NOTICE OF APPEAL

| b) Zoning Administrator: | <u>PLN160348</u> | <u>* demolition/construction</u> | <u>* Carmel Area Land Use Plan</u> |

Re: Meyer Appeal of PLN160348
Our File: 34910.33559

RE: Proposed Roof Deck – 2874 Pradera Road, Carmel Meadows

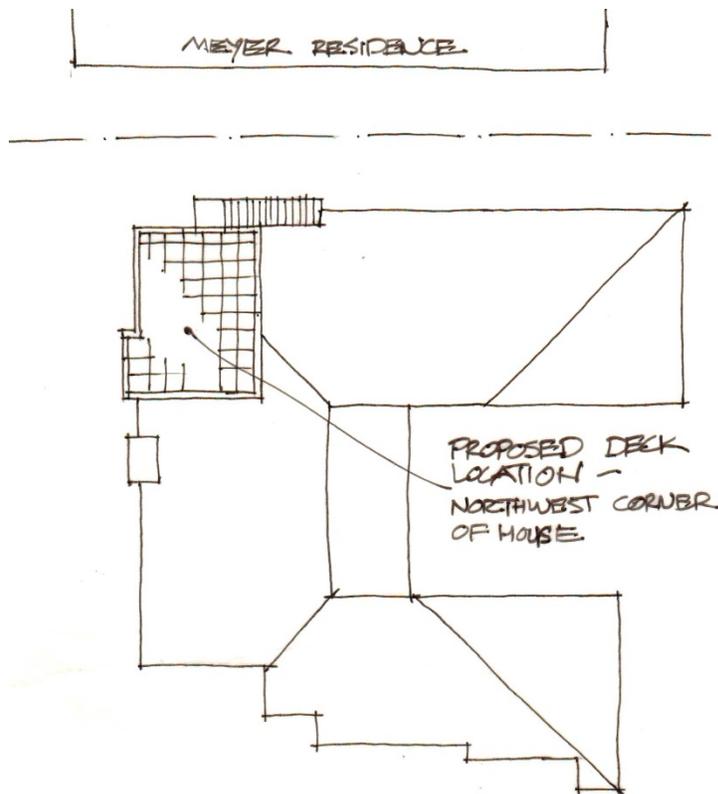
The proposed roof deck is located very close to the master bedroom of Ms. Meyer's home. The impact of this proposed deck takes several forms:

1. Intrusion of Privacy: The deck, and stair accessing the deck, are approximately ten feet from the bedroom windows, at a level just above the windows. Persons on the deck and stair can look directly down into the privacy of the bedroom.

2. Loss of south light: Because of the intrusion noted above, the only recourse Ms. Meyer has to protect her privacy is to close her curtains, blocking access to light, view and ventilation.

3. Noise intrusion: Roof decks are normally social gathering places, in this case for persons to enjoy the outdoors and extensive view over the ocean and Point Lobos. The resulting conversation and social activity will project right into Ms. Meyer's bedroom, interrupting sleep and use of the bedroom for quiet activity.

4. Loss of view: The orange netting demonstrates the direct impact of the deck on Ms. Meyer's view of Point Lobos. Although protection of views is not included in the Monterey County Zoning Ordinance, balancing of all elements of use of properties is the goal of design review. It is apparent that the developer of the new residence desires to include a roof deck to enjoy this special view, but the location of the deck means that this enjoyment is at the expense of the neighbor's view (in this case Ms. Meyer).

Proposed deck location at northwest corner of house

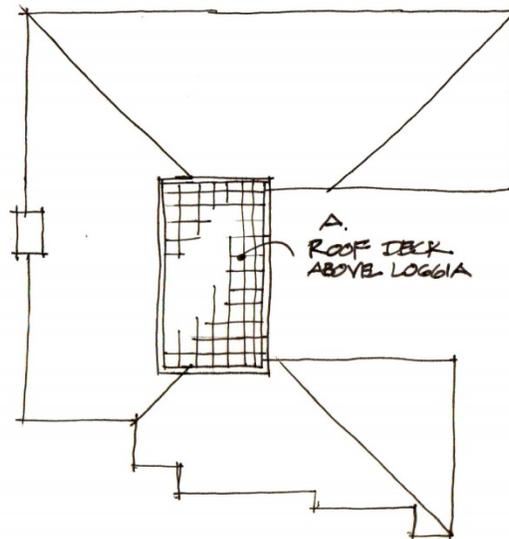
- It appears that the deck was located at the northwest corner of the house to locate the deck with its noise, massing, and view as far from the south property as possible. This would best protect the privacy of the owners of the property to the south, who are developing this new residence and who have made design decisions to protect their own enjoyment of their property. (It is unfortunate that the resulting design does not balance the developers' desire to protect their privacy with their neighbors desire for the same, which is possible to achieve if pursued by the developer.) The sketches below keep that premise in mind, although some options are less intrusive on the south property than others.

Providing a greater distance between the proposed deck and the existing north neighbor's bedroom would go far to reduce intrusion on privacy and noise intrusion. In addition, if the deck is nestled into

the roof structure both visibility of the deck (not from the deck) and noise emanating from deck activity could be lessened considerably.

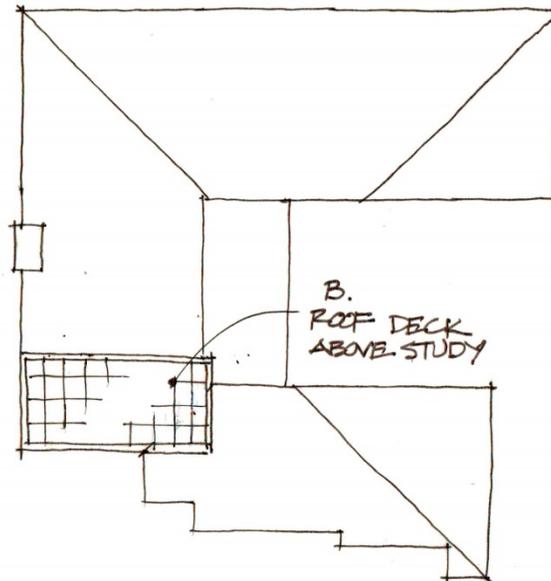
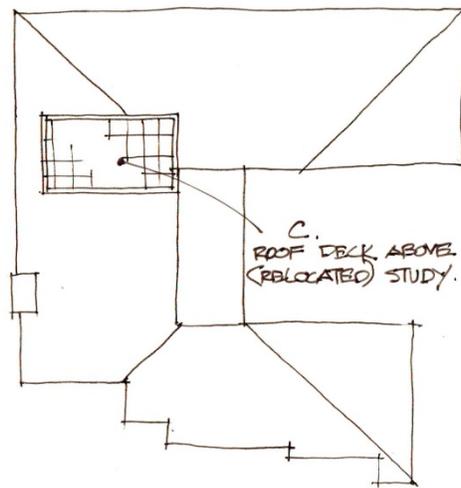
There may be any number of possible deck locations which would provide a great view deck for the proposed residence, while protecting the privacy of the south property and eliminating or minimizing the impact on Ms. Meyer's property. I have sketched three:

Option 'A' – Roof Deck above Entry Loggia: In this option the deck would be located on the flat roof area above the entry, far back from any neighboring properties while enjoying a panoramic view.

Option 'B' – Roof Deck above Study: Location of the roof deck over the study would avoid impacting the vaulted ceiling of the living space. It would be located closer to the south property, but based on the

house setbacks it would be a good distance (17'-4") from the south property line. Introduction of screen hedges on the south property line would further minimize any possible privacy issue.

Option 'C' – Roof Deck above relocated study: By reconfiguring the interior layout, the deck would be located in the north center of the roof, far away from the south property yet a sufficient distance from the north property line to better protect Ms. Meyer's privacy.
